Amendment of the Zoning Resolution pursuant to Section 200 of the New York City Charter relating to Section 98-00 (Special Manhattan Landing Development District) concerning changes to the District Parcel Improvements for District Parcel 20Q and District Parcel 21, and the related portion of the District Plan in order to accommodate a proposed 38 story office building to be developed for the Continental Insurance Company.

This proposed amendment would require the construction of an enclosed street level public space on District Parcel 20Q and District Parcel 21, in exchange for the pedestrian circulation facilities previously required on these parcels. A proposed 38 story office building for the Continental Insurance Company on these parcels will be governed by the provisions of this proposed amendment. Other actions related to Parcels 20Q and 21 include

District Parcel 21

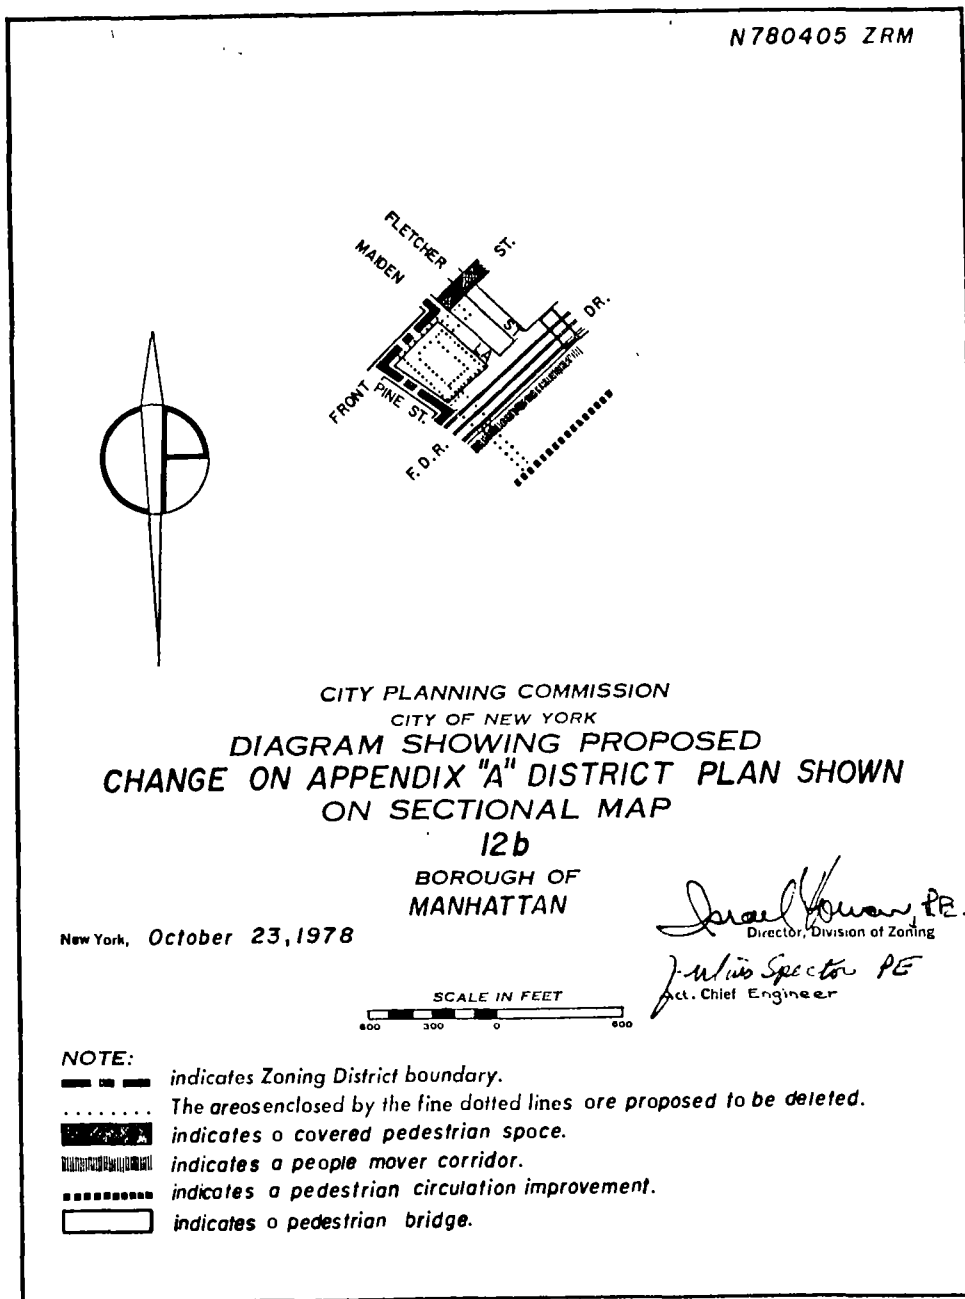
1. An *open pedestrian bridge* or *enclosed pedestrian bridge* at the intersection of the southeast *street line* of Front Street and Maiden Lane, connecting with the *pedestrian connection* in *district parcel 20Q* at the corner of Front Street and Maiden Lane and connecting with the *covered pedestrian space* or the *pedestrian way* or the *loggia* and Front Street as described in 2, below.

2. A *covered pedestrian space* bounded by the southeast and northwest *street lines* of Front Street as in existence on the effective date of this chapter, or a *pedestrian way* within such boundaries, continuous between Maiden Lane and John Street and connecting with the *through block arcade* described in 3, below, should *district parcel 21* consist of one *development* on all blocks in the district parcel. If *district parcel 21* consists of more than one *development* a *loggia* shall be required along the southeast street line of Front Street, continuously between the *pedestrian bridge* described in 1, above and John Street, connecting with John Street and the *through block arcade* described in 3 below.]

1. An *open pedestrian bridge* connecting the *pedestrian way* on District Parcel 14 with the *through-block arcade* described in 3, below.

2. A *covered pedestrian space* bounded by the southwest and northeast *street lines* of Front Street as in existence on the effective date of this Chapter, or a *pedestrian way* within such boundaries, continuous between Maiden Lane and John Street and connecting with the *through-block arcade* described in 3, below, should *district parcel 21* consist of one *development* on all blocks of the district parcel. If District Parcel 21 consists of more than one *development* such *covered pedestrian space* shall be provided only if Front Street as described above is entirely within the *development* and can be provided with an entrance on John Street or Maiden Lane.
